ARCHITECTURAL ADDENDUM NUMBER THREE

NKU – UK College of Medicine
3rd Floor Albright Health Center Renovation
CMTA Engineers
Addendum #3
August 06, 2018

3rd Floor Albright Health Center Renovation

ADDENDUM #3

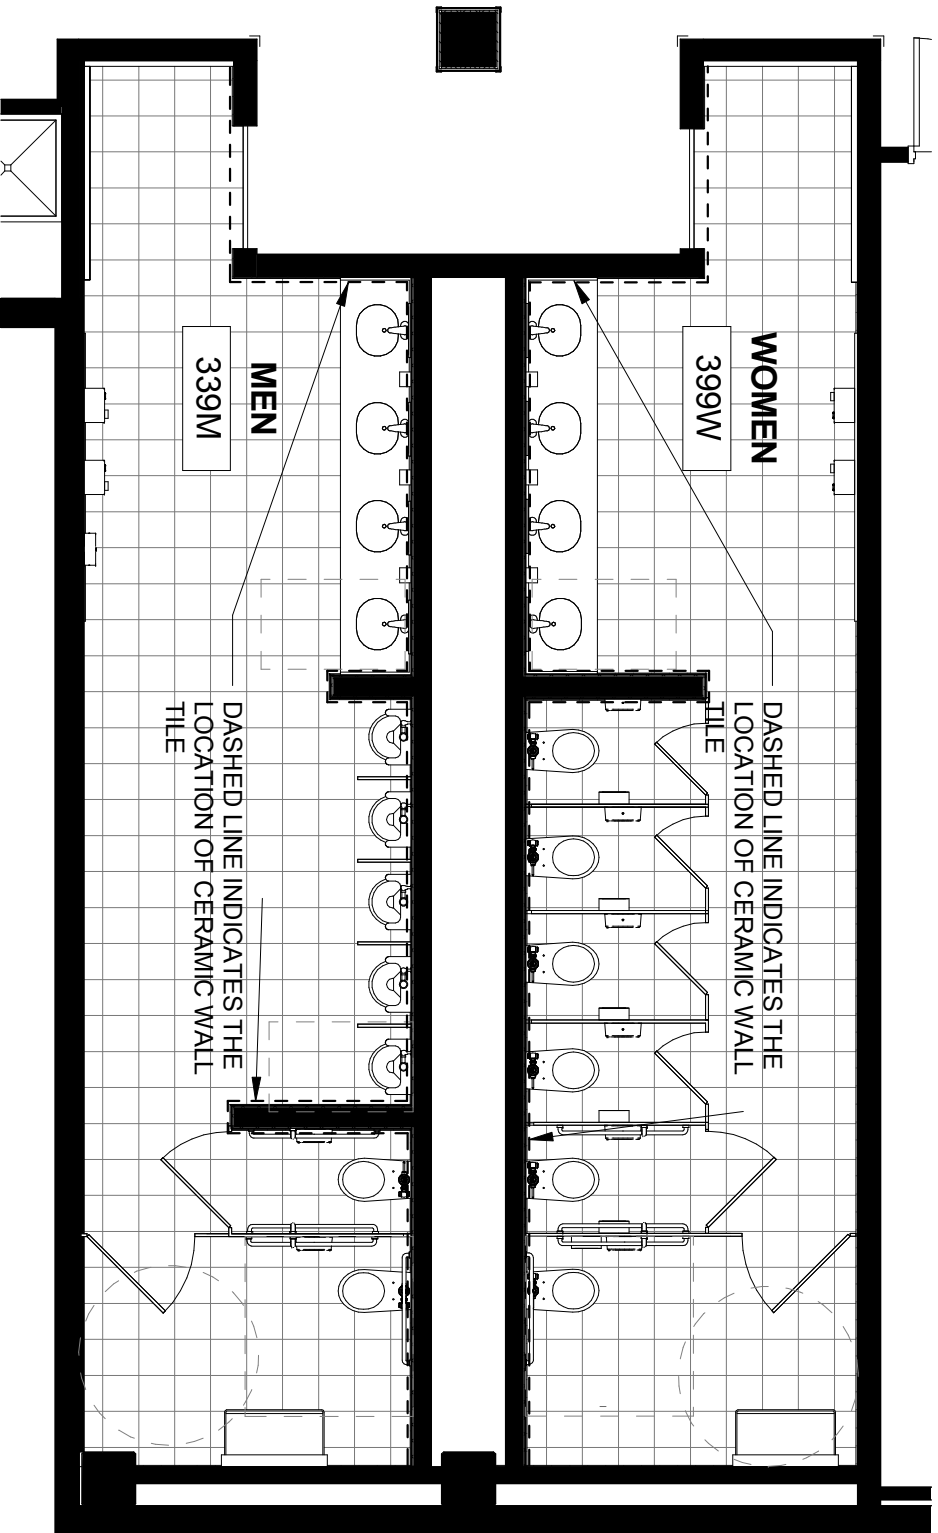
22. Elevation 13/A-5.2 shows wall tile on wall with Door Opening to Corridor, however, dotted line showing extents of wall tile do not include this wall. Please clarify which walls are intended to receive wall tile.

Omni Response: Elevation 13/A-5.2 is correct. Refer to the attached supplemental drawing ADD-3.1 from Omni Architects dated August 6, 2018 for the required extents of wall tile in the public restrooms.

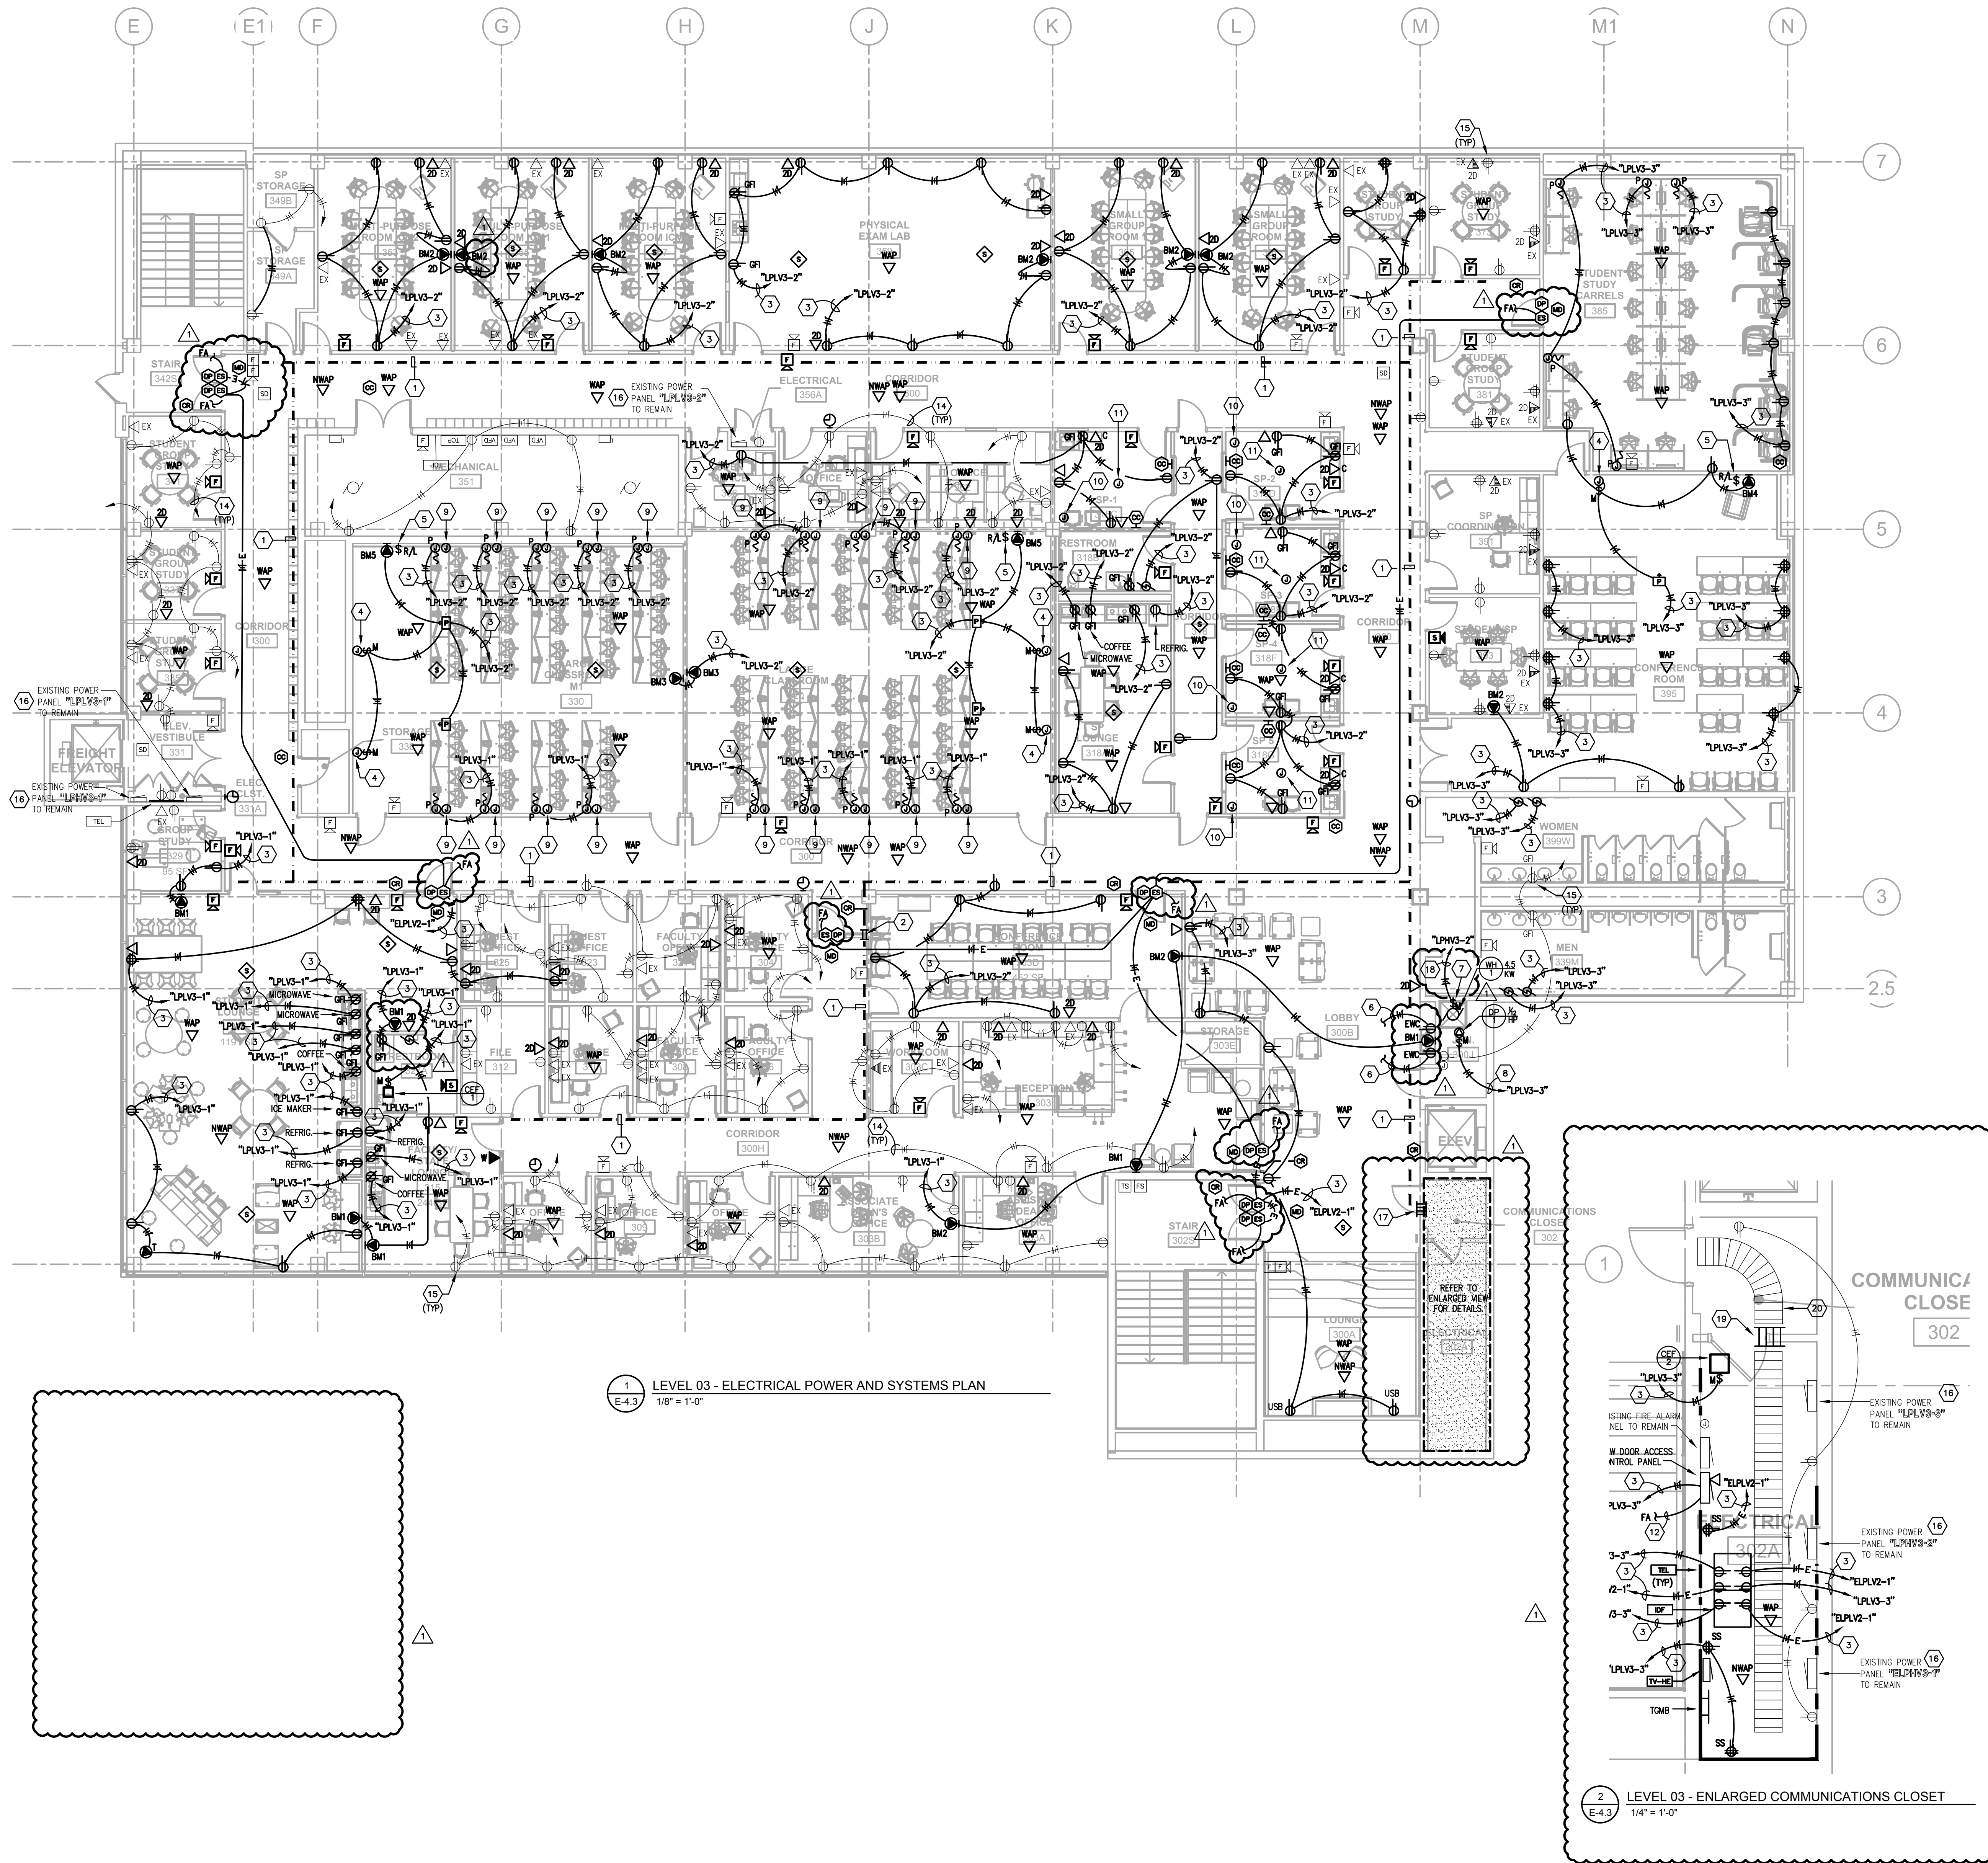
2. Add Sheet E1.3
 - a. Refer to ADDED Sheet E1.3 – Partial Level 1 and 2 – Interconnection Plan for location of fire alarm control panel, main service switchboard, etc.

- b. Ground conductor for new IDF to be routed and connected to Switchboard DSB1 service ground bus.
3. Sheet E2.3
 - a. General note: Replace “ALL EXISTING DATA DROPS ON THIRD FLOOR ARE TO BE REPLACED WITH CAT 6 CABLING HOMERUN TO NEW IDF RACK. REFER TO DATA VOICE SPECIFICATIONS FOR NEW CABLING, JACK, AND PATCH PANEL REQUIREMENTS” with “ALL EXISTING DATA DROPS ON THIRD FLOOR SHALL BE REPLACED WITH CAT 6A CABLING HOMERUN TO NEW IDF RACK AND NEW FACEPLATES AND CAT 6A JACKS. REFER TO DATA VOICE SPECIFICATIONS FOR NEW CABLING, NEW JACKS, AND NEW PATCH PANEL REQUIREMENTS.”
